Eaton Corporation
Operations & Technical Center
4201 North 27th Street
Milwaukee, Wisconsin 53216
Telephone (414) 449-6000

July 8, 1983

During the qualification testing of aged electrical equipment for the Perry Nuclear Project certain anomalies occurred. These anomalies were in apparatus which had been artificially aged using Arrhenius methodology with elevated temperature aging.

The equipment involved was A-C and D-C low voltage motor starters in motor control centers.

FIGURE 1

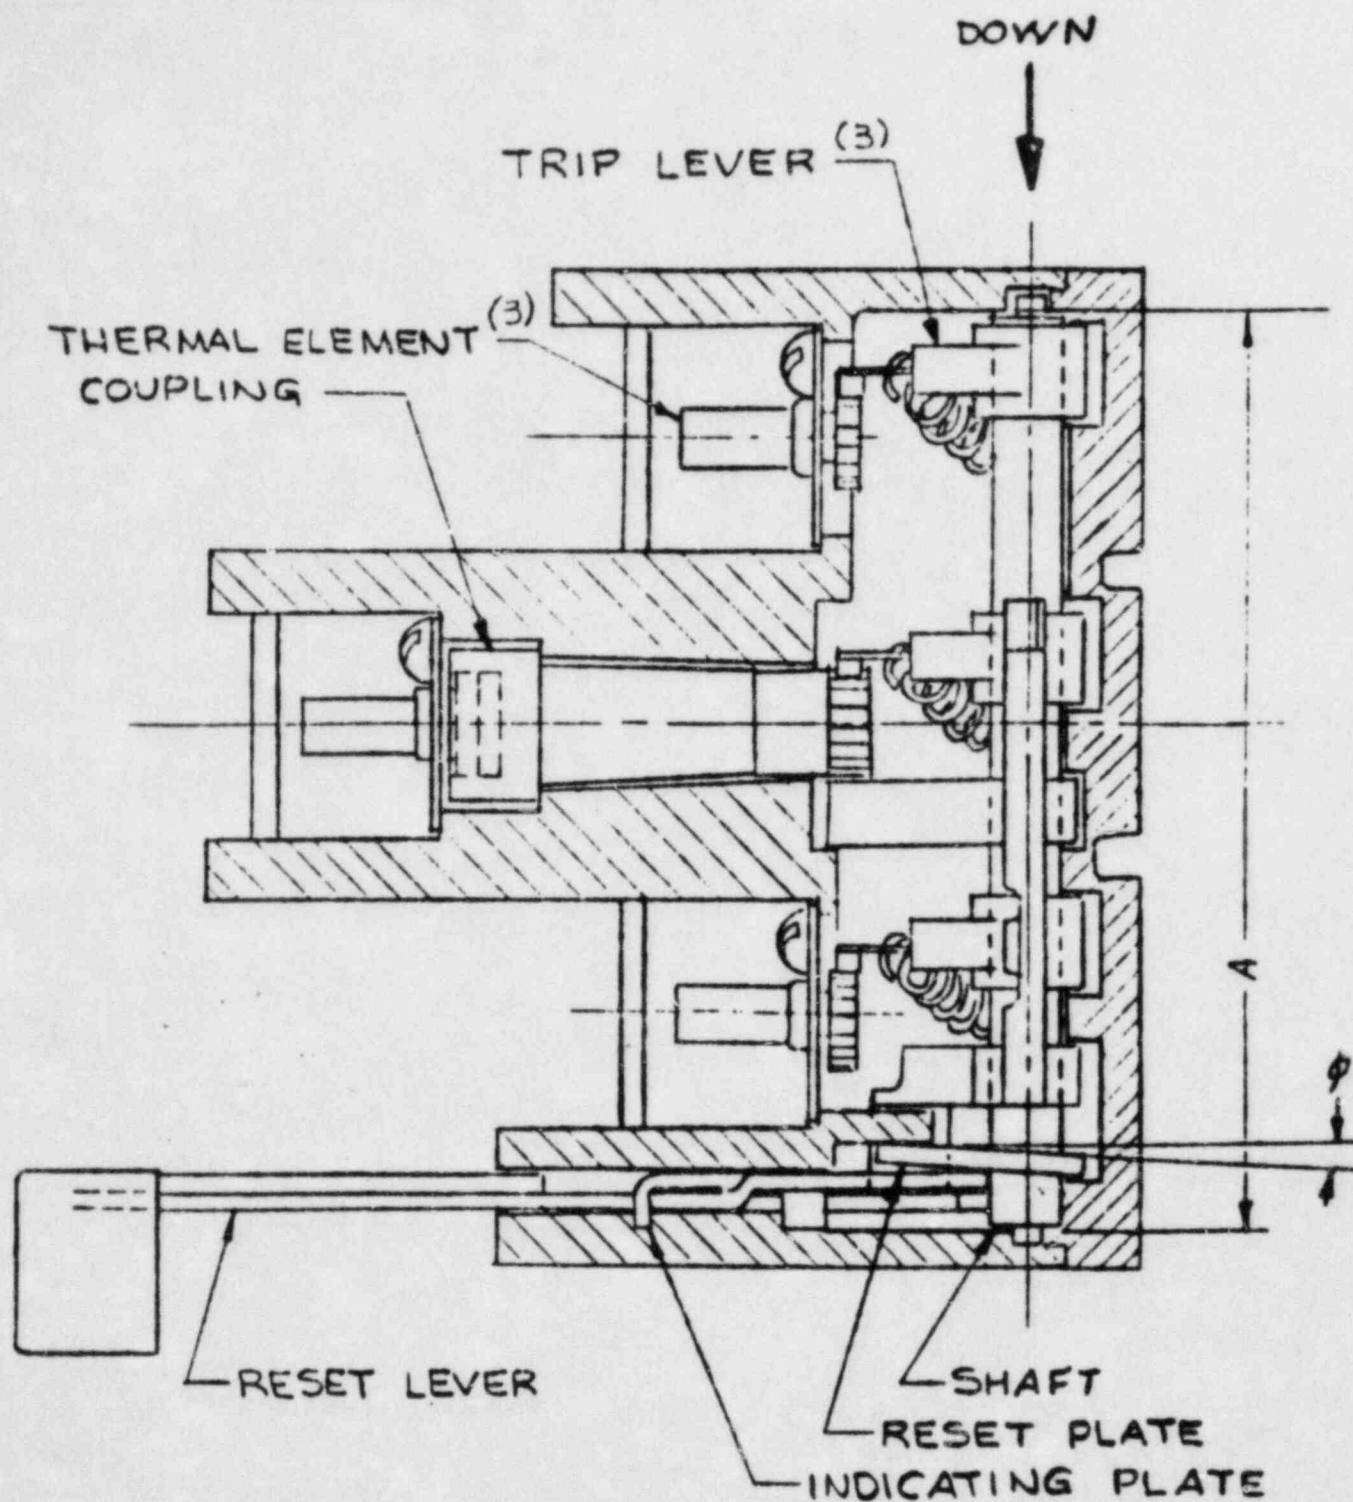
Our records show that you have motor control centers containing NEMA size 1 and 2 motor starters with thermal overload relays mounted 90° counterclockwise from vertical on a vertical panel. Our records further indicate that some of these overload relays are in safety-related (Class IE) apparatus.

If it is desired to insure future operability and to check function, we would recommend periodic exercising of the trip function of these devices. Such exercising should prevent future occurrence and may correct this anomaly if it has already occurred.

Mechanical exercise of the overload relay at the job site can be accomplished as follows:
(Reference Figure 1)

1. Disconnect power from the motor control center unit. Open unit door.
2. Remove the two outer heater coils (poles 1 and 3).
3. Loosen the two outer thermal element mounting screws 1 to 1-1/2 revolutions.
4. Using the thermal element screws as pivots, tip the thermal elements in pole 1 and 3 toward the contactor (or toward the line side terminals for the case of component overloads). This disengages the trip levers from the thermal elements thus effecting a trip-out.

Monitoring the overload relay contacts during this procedure should indicate a change of state as the overload relay trips.

5. Hold pole 1 and 3 thermal elements in place by hand and fully depress the reset button. Upon release of the button, the overload contacts should return to the reset state.
6. Replace the overload relay if it fails to trip or reset.
7. Repeat step 4 and 5 for three operations.

FIGURE 1

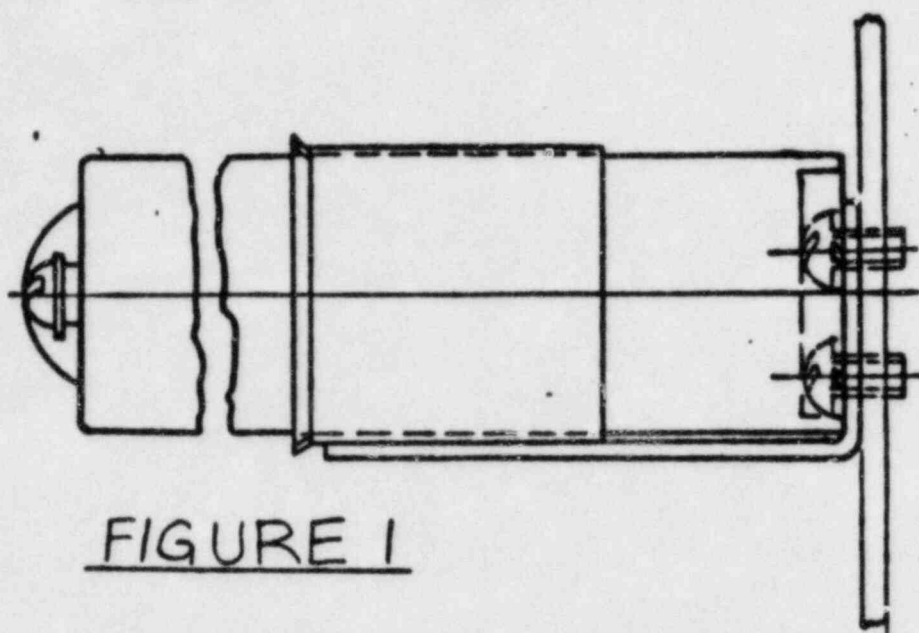
It is highly unlikely that your plant contains this condition since the cause was a reduction in length of the capacitor which most likely did not occur until after the centers in your plant were shipped.

Most likely your plant has capacitors mounted per Figure 1 on the attached with the 8" capacitor. There is no problem with this arrangement.

FIGURE 2

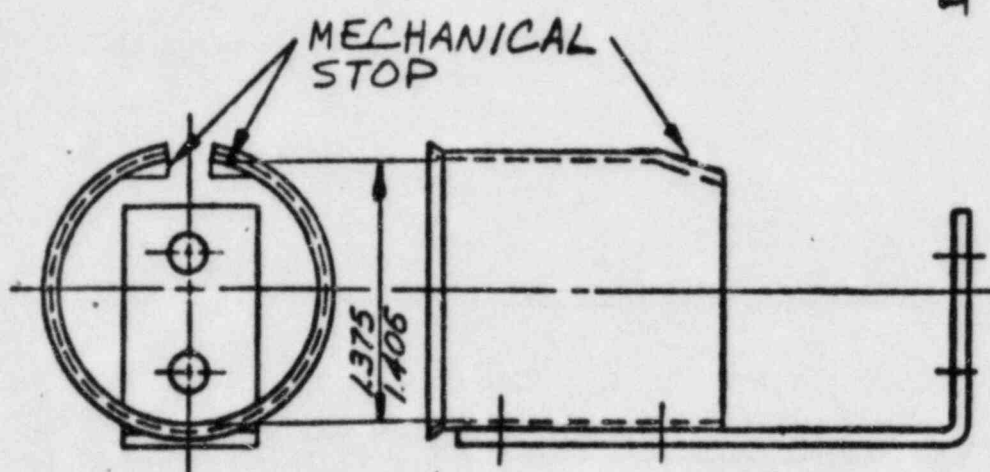
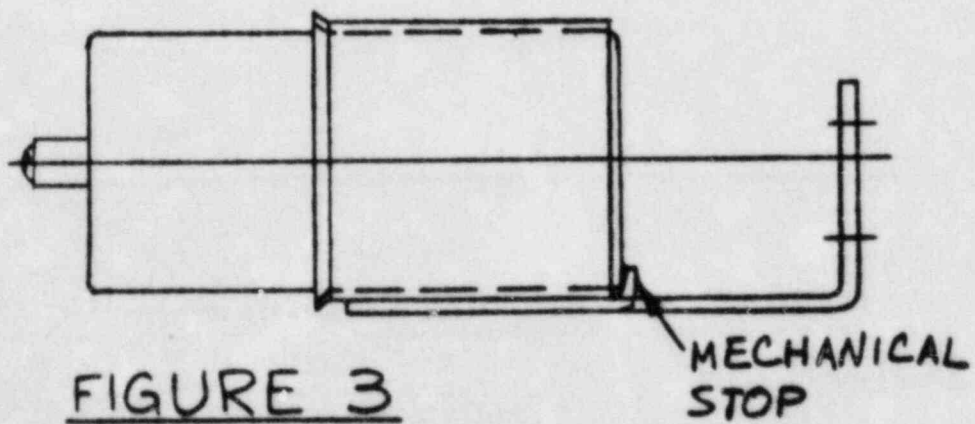
Our records show that you have D-C motor control centers containing NEMA size 1 and 2 reduced voltage motor starters. These starters contain accelerating relays, part number 10-3486 (#538) for the size 1 and part number 10-3487 (#673) for the size 2. Our records further indicate that some of these accelerating timing relays are in safety-related (Class IE) apparatus.

If you have the Figure 2 bracket with the shorter capacitor, it should be replaced with bracket part number 55-496 per Figure 3. The capacitor should also be replaced. The capacitor part number depending on the capacitance and voltage rating are: 42-143 (25MFD-300V), 42-143-2 (75MFD-150V), 42-143-5 (50MFD-300V) and 42-143-6 (150MFD-150V).
